ZONING CHANGE REVIEW SHEET

CASE: C814-2014-0110.SH **Z.A.P. DATE:** September 16, 2014
Colony Park Sustainable Community Initiative PUD

Subject: Colony Park Planned Unit Development SP-2013-0295DS

SLOPE MAP

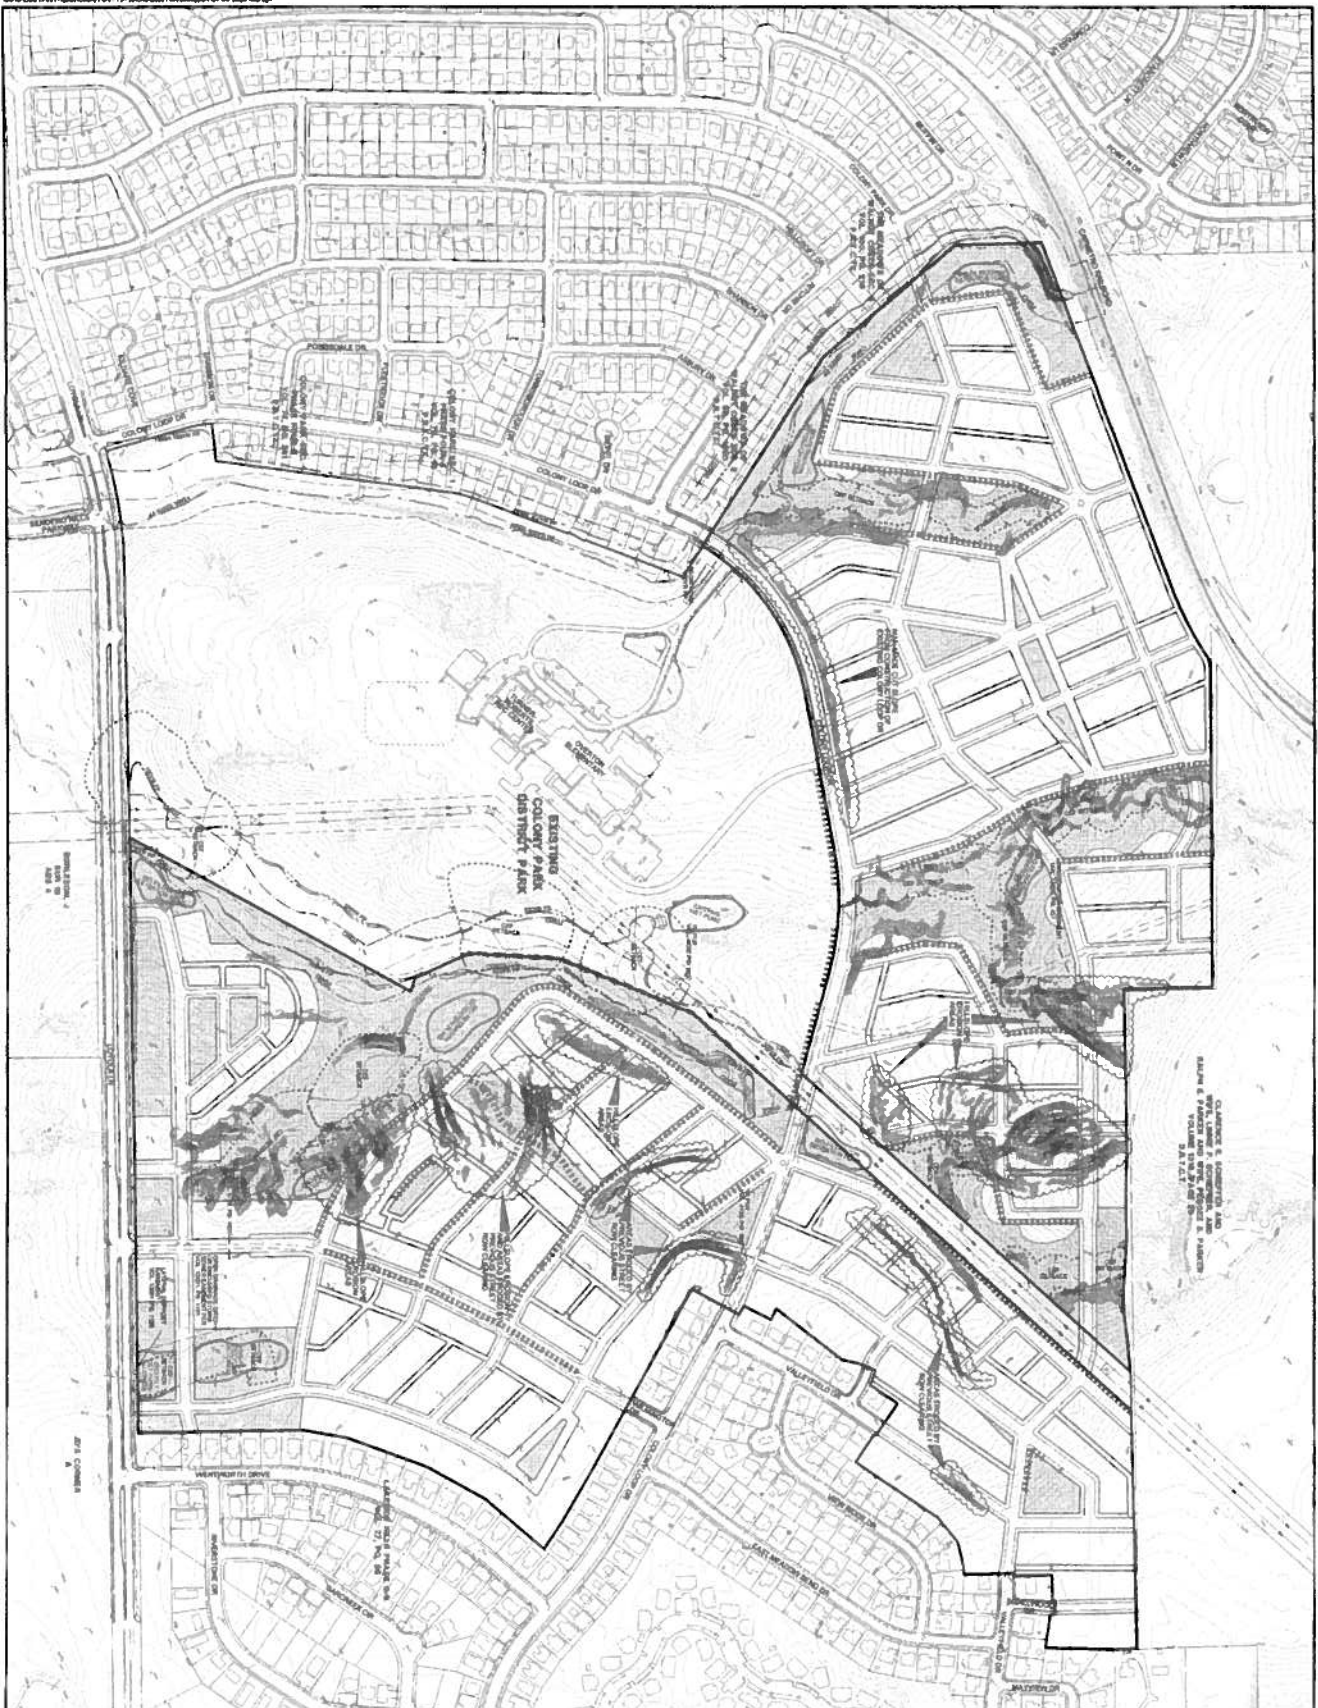
EV 02 Please provide a slope map showing:

In addition, provide an overlay of the proposed development (lot lines, building footprints, proposed water quality / detention ponds, roadway alignments, etc) on this exhibit. Additional construction on slopes review and comment may be pending.
